NOVEMBER 2019

PL6

NON MATERIAL
AMENDMENT
PLANNING
APPLICATION
& CONDITION 4
DISCHARGE

44 A GLOUCESTER
AVENUE LONDON
NW1 8JD

2.1 CHANGES TO CONSENTED DEMOLITION BASEMENT AND GROUND FLOOR

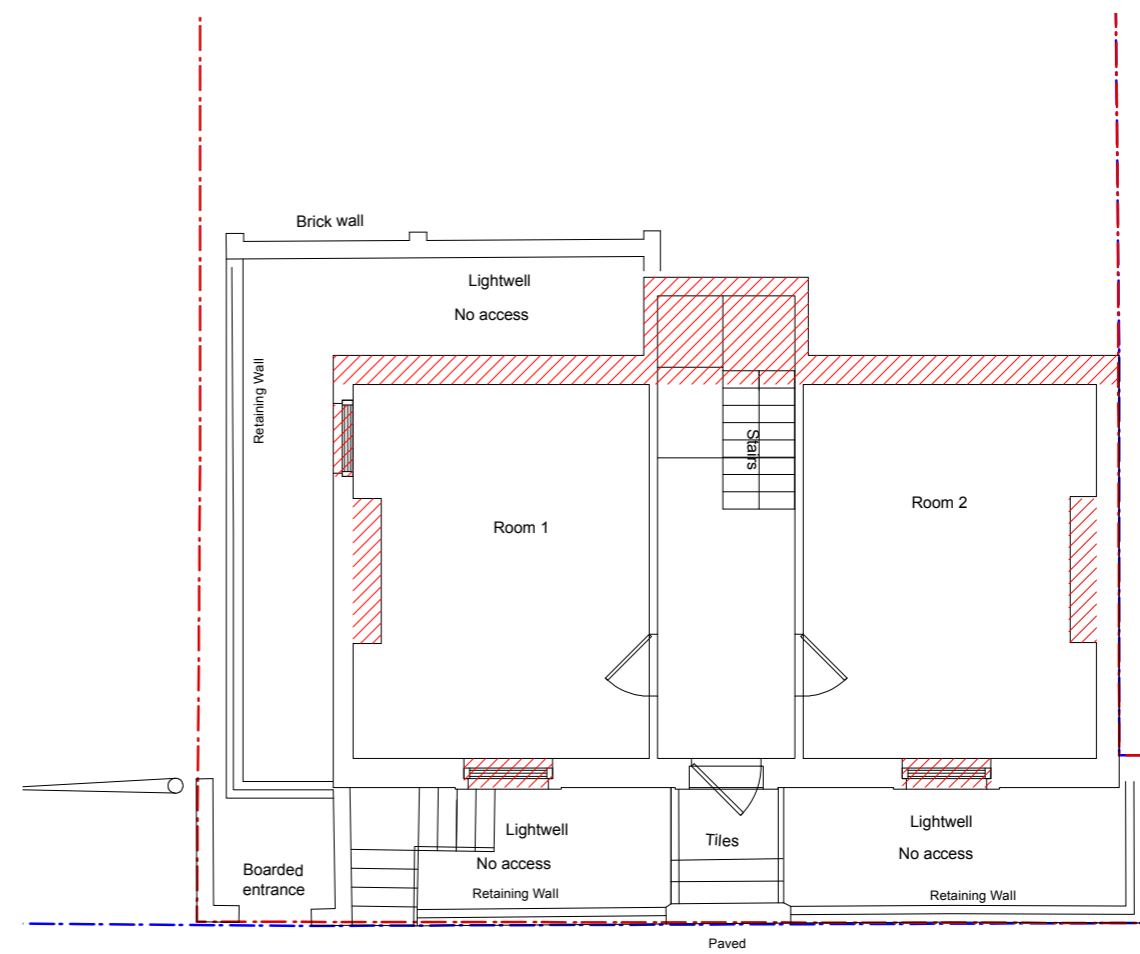
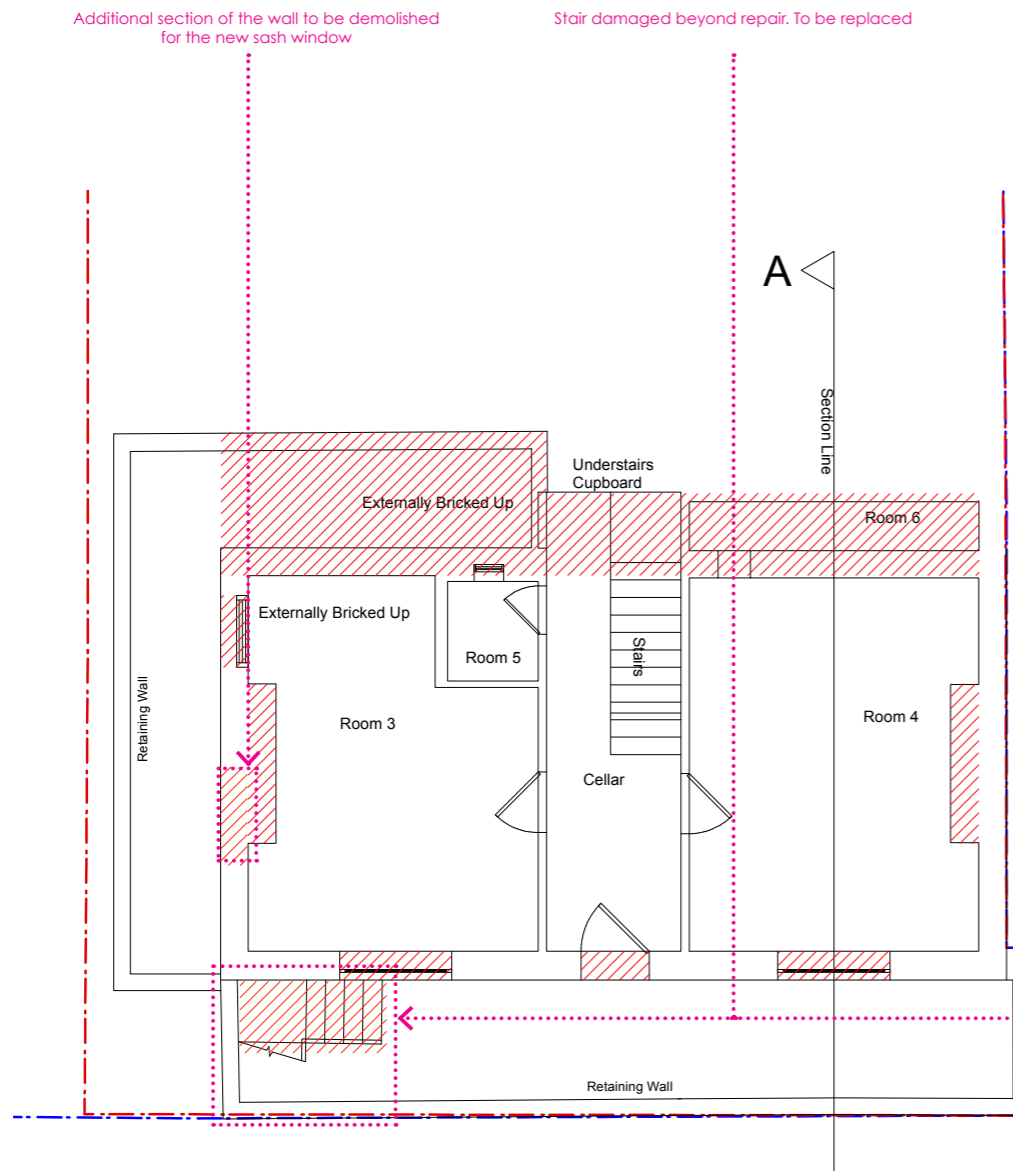
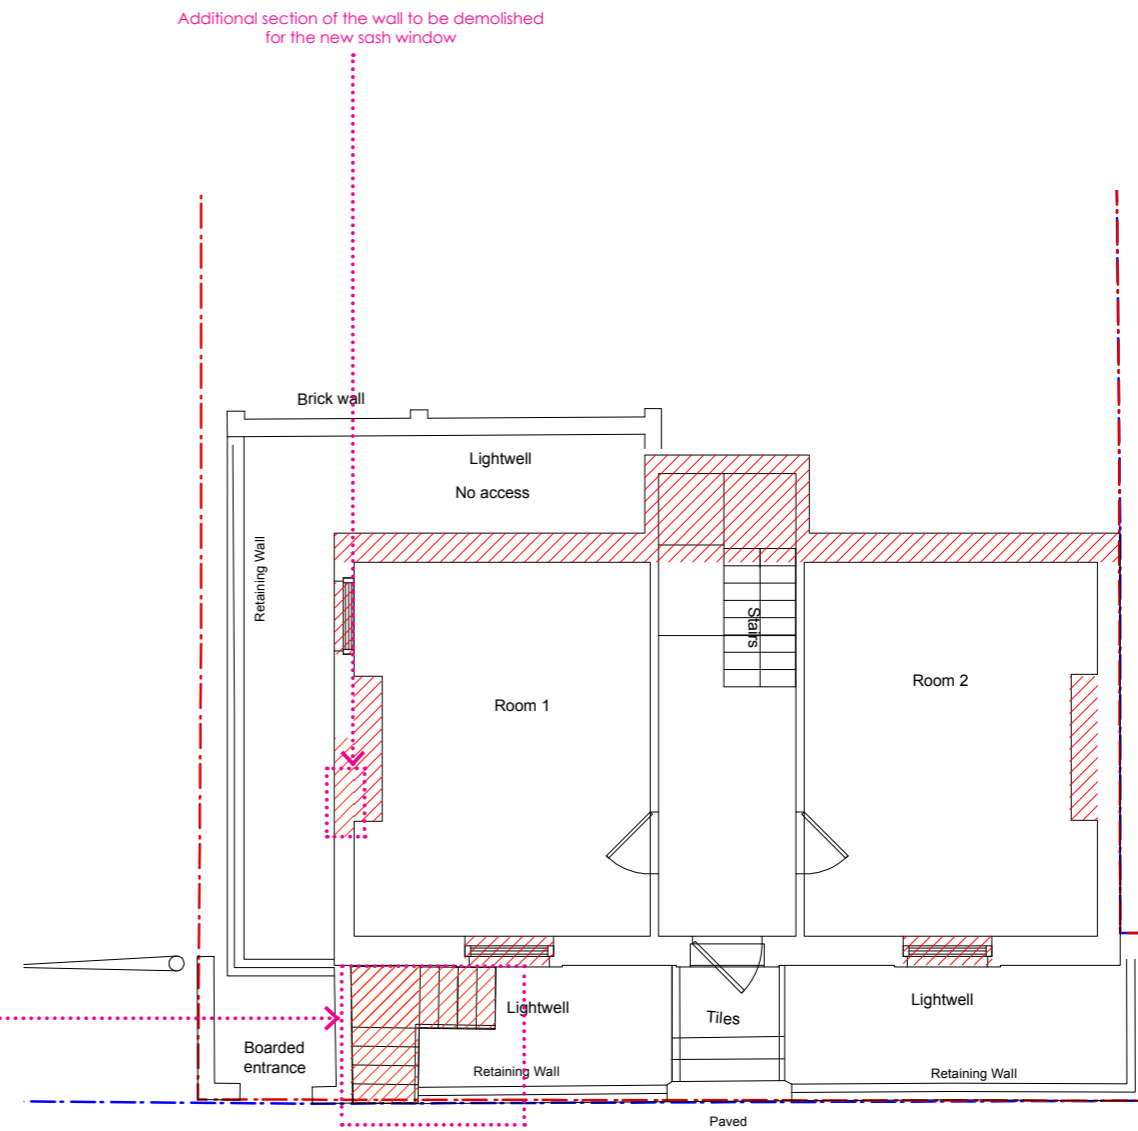
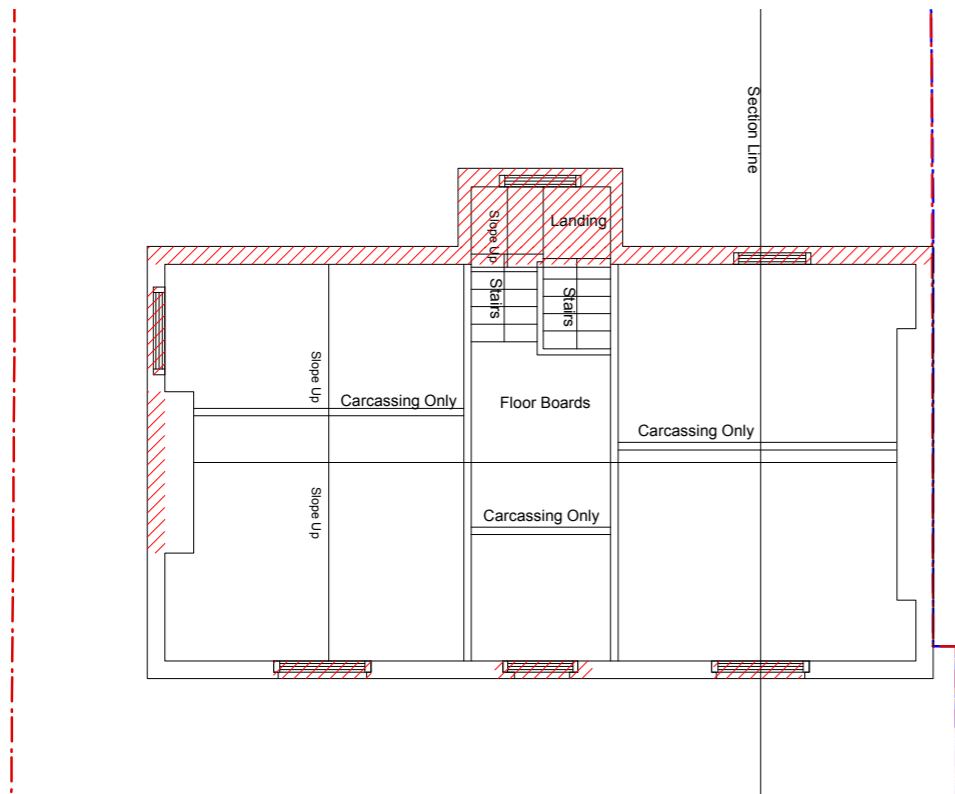
- Due to incorrect initial survey basement front balcony opening has been revised in the demolition drawings
 - Demolition drawings have been revised with correct openings in the side elevation and other minor changes

- 1.44 Due to difficulties in correctly surveying the house prior to the initial design, minor changes to the consented demolition drawings have been submitted to bring the design into line with accurate survey data.

173_PL1_DN_01_P1
REVISED PROPOSED DEMOLITION FIRST FLOOR PLAN

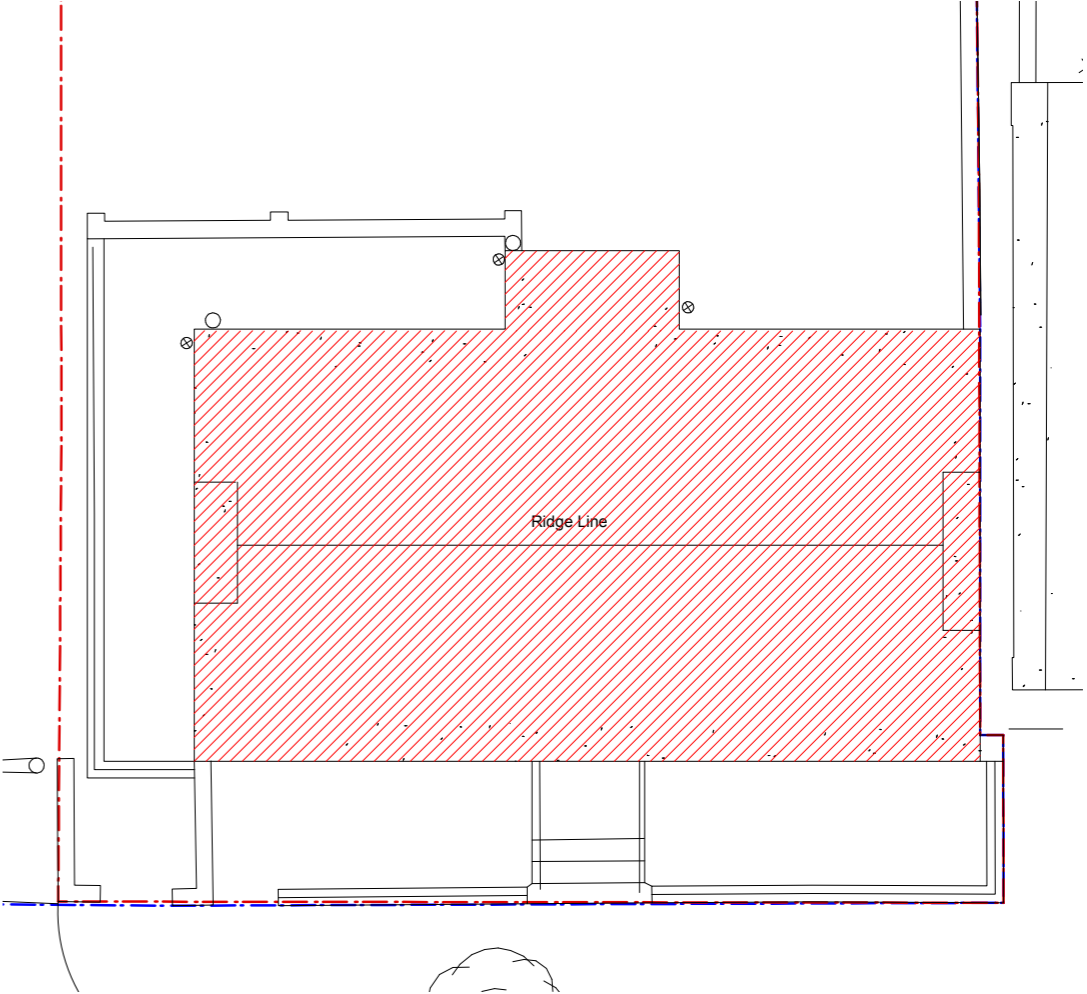
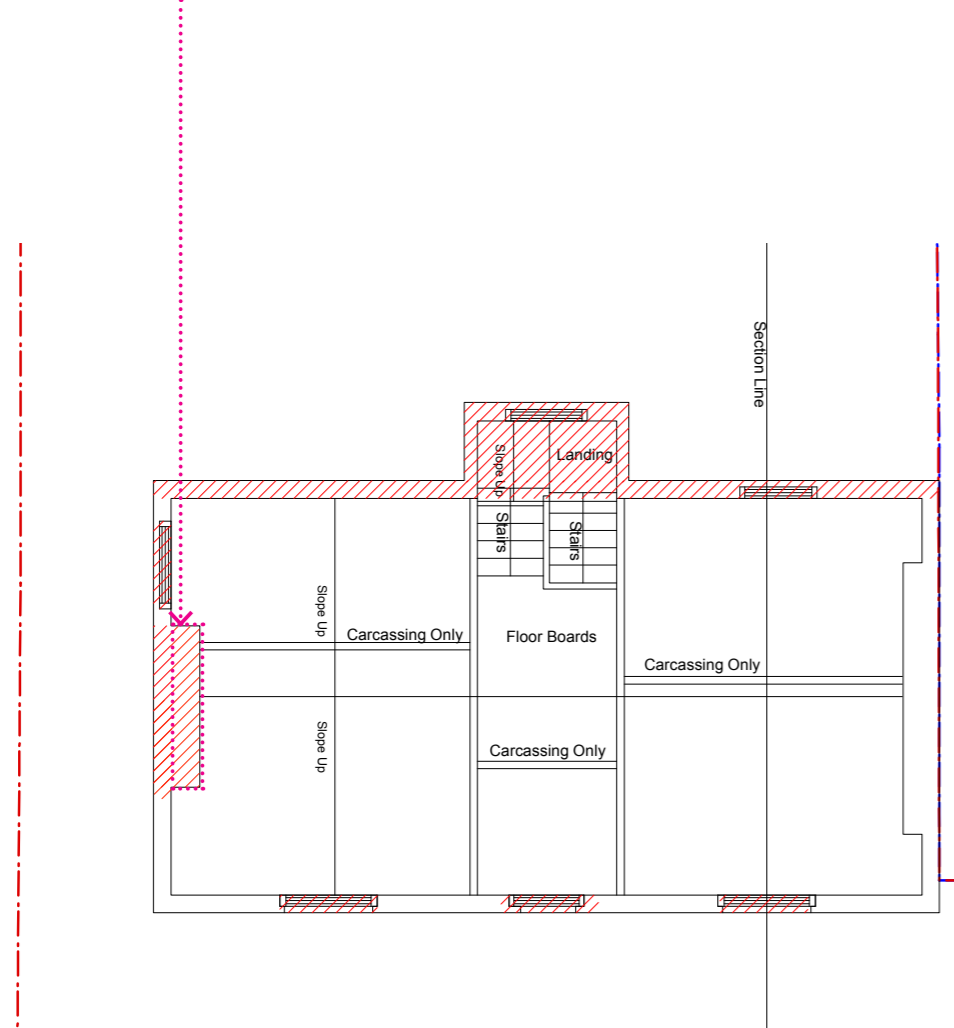
Additional opening made for the new window.
Internal chimney breast to be demolished due to poor existing condition
